Redfern North Eveleigh Precinct team
Department of Planning, Industry and Environment

22nd August 2022

Re: Paint Shop sub-precinct rezoning proposal

Figure 1: Illustrative master plan (Source: TfNSW/Bates Smart)

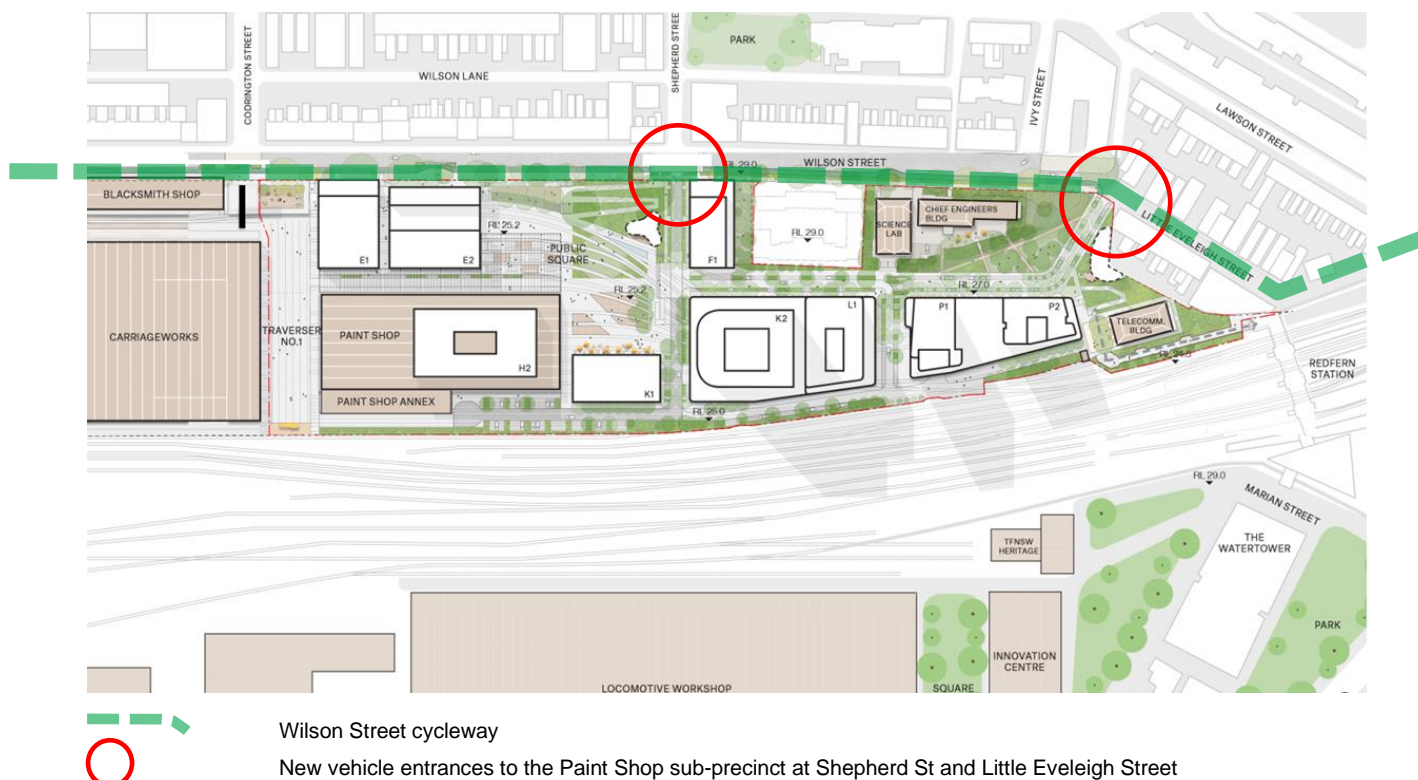
Bicycle NSW welcomes the opportunity to discuss our concerns and recommendations regarding the North Eveleigh Paint Shop sub-precinct rezoning. Our submission focuses on the impacts to the Wilson Street cycleway during and after construction (Figure 1), the vehicle movements into and within the site and the lack of future active transport connections to South Eveleigh.

It is recognised that the rezoning proposal does not include detailed engineering for the streets and public spaces of the Paint Shop sub-precinct. However, we respectfully ask that the future design development of the site prioritises walking and cycling over private car use, and maintains the integrity of one of Australia's busiest bicycle routes.

Figure 2: Pedestrian and cyclist movement network (Source: TfNSW/Bates Smart/Turf)

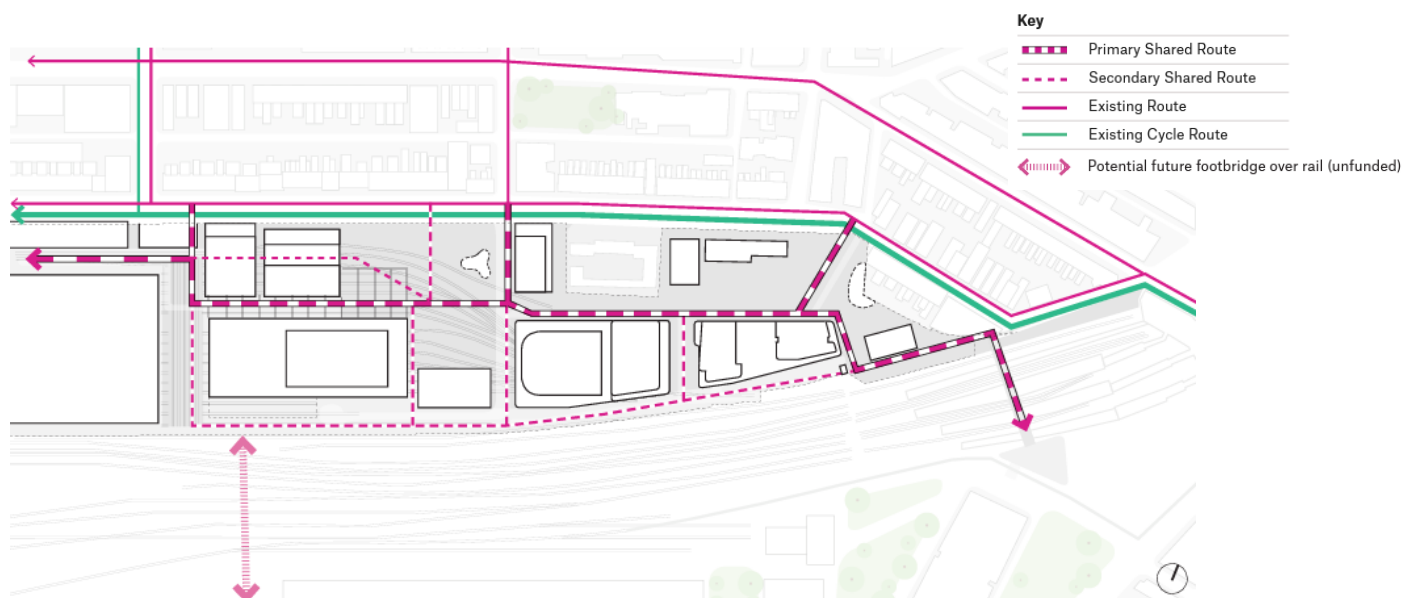
A shared and fully accessible street network is proposed within the sub-precinct. The project team promises urban design that prioritises walking and cycling, with a key east-west distributor linking Redfern Station with the Carriageworks sub-precinct (Figure 2). Separated cycleways will not be needed and we agree with this approach provided very low speed limits of 10km/hr are applied across the site.

A footbridge over the rail lines is indicated in the circulation diagram in Figure 2. However, it is not mentioned again in the document except for a page in the Appendix (Figure 8) where the project team states that *'detailed consideration is outside the project scope and does not have NSW Government funding'*.

Figure 3: Vehicular movement network (Source: TfNSW/Bates Smart/Turf)

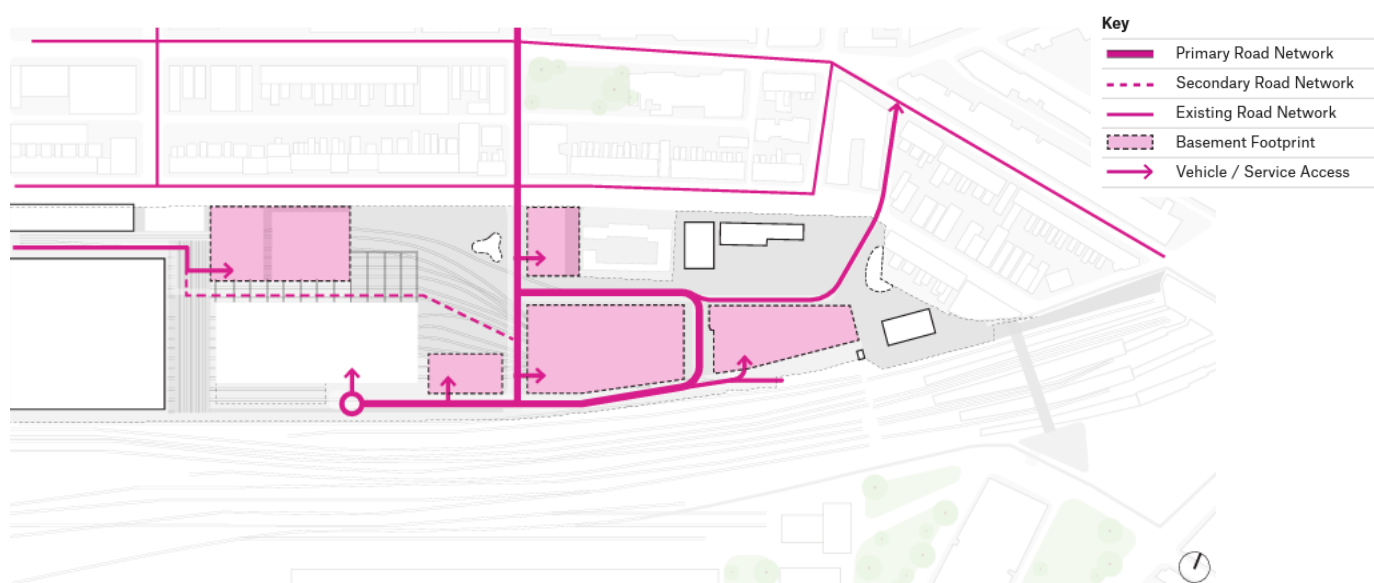
Vehicles entering the site will be concentrated on a new main north-south main road (Figure 3) created by extending Shepherd St south across Wilson St and its cycleway (Figure 4). The road will provide access to loading bays and basement car parks ensuring minimal vehicle movement across the rest of the precinct.

The Wilson St bi-directional bicycle path is safe due to its separation from traffic. The development of the Paint Works sub-precinct as a dense, highly-activated, mixed-use urban centre will lead to high levels of vehicular movement across the protected cycleway via the two new road access points, at Shepherd St and the western end of Little Eveleigh St.

Adding busy road intersections to Wilson St cycleway will be an inconvenience for cyclists and reduce its attractiveness as a regional cycle route that encourages people of all ages and abilities to take to their bikes. Concerns have been raised that drivers crossing the cycleway may not be watching for cyclists to both left and right.

- Great care must be taken control any risks for bike riders created by the increased traffic burden. Road furniture such as raised platforms, narrowed streets and extended curbs for pedestrians create a shared space that calms traffic and is safe for pedestrians and cyclists.

- Cars crossing the Wilson St cycleway must give way to bicycles at all times. This priority must be made clear through design elements that favour walking and cycling, enforced with signage and CCTV. If traffic signals are installed at either or both driveways, phasing must favour cyclists and pedestrians over private vehicles.

- In addition, the proposed 30km/h speed limit for the southern extension of Shepherd Street is too high and unacceptable. Vehicles should be subject to the same 10km/h limit that will apply to the shared spaces across the sub-precinct.

Figure 5: Proposed vehicle exit, corner Wilson St and Little Eveleigh St (Source: Bicycle NSW)

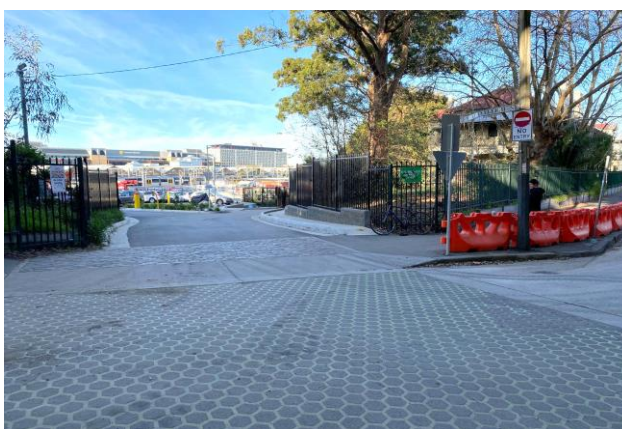
Vehicles will be able to leave the sub-precinct from the two-way Shepherd St entrance, or by looping through the one-way shared central spine up to the end of Wilson Street where it intersects with Little Eveleigh St (Figure 5). Cars would not be permitted to turn right, and will be directed straight ahead via Ivy Lane.

Figure 6: Plan showing access points to Wilson Street (Source: TfNSW/Bates Smart/Turf)

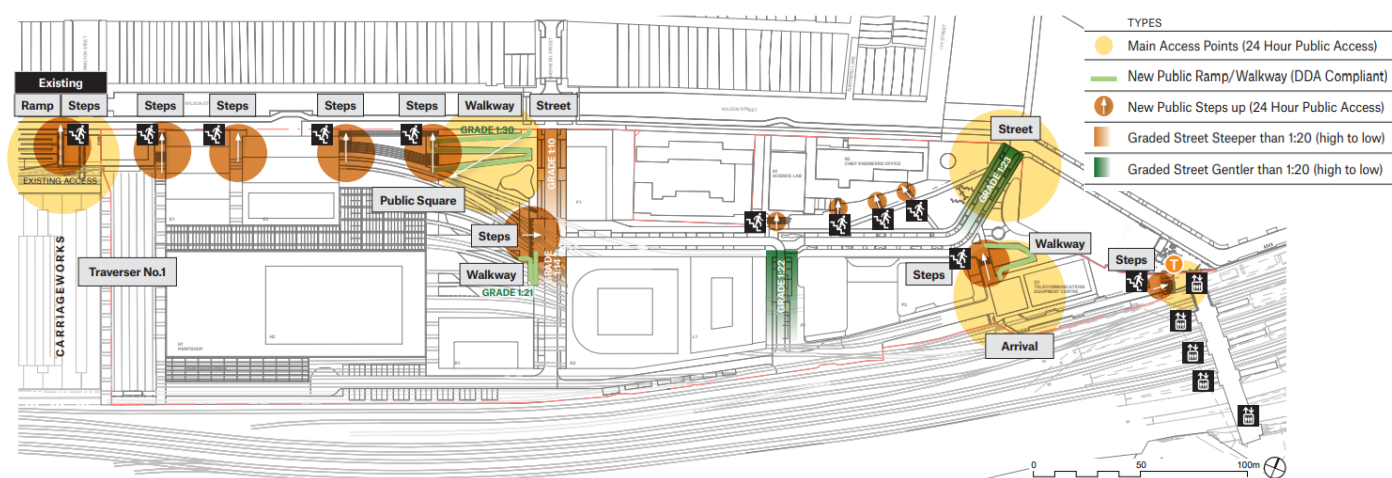
However, it is clearly stated in Section 9.2.7 (page 106) that main vehicular access point at the junction with Shepherd Street **does not meet accessibility standards**. The road gradient will be approximately 1:10.

According to Austroads Guide to Road Design Part 3: Geometric Design: Part 8.5 Gradesⁱⁱ, heavy vehicles will struggle going both up and down hill when gradients exceed 9% (Part 8.5.2). Grades of over 6% should be avoided for lengths over 300m (Part 8.5.4).

Vehicles leaving the sub-precinct via Shepherd St will need to accelerate to climb up to Wilson Street. Increased speeds will add to the danger of conflict with pedestrians, cyclists and other vehicles, particularly

at the intersection with the cycleway. Drivers facing uphill will have poor sightlines to people and vehicles at the crest of the hill.

- Urgent studies must be instigated to clarify how the Shepherd St will work within the precinct to create a safe, accessible and attractive access road. It may be necessary to completely re-think the strategy for vehicular access to the site.

Figure 7: The misleading cross section of Shepherd Street which ignores the change in level (Source: TfNSW/Bates Smart/Turf)

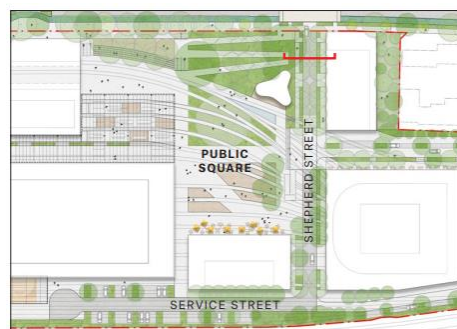
In addition, there is a lack of information about how such a steep street will work alongside the park, footpaths and building frontages. There are no long sections showing how the road connects Wilson St to the level of the Fan of Tracks public square, and the only cross section (Figure 7, from Section 10.7.10) ignores the slope. Bicycle NSW is concerned the resulting street will have a canyon feel.
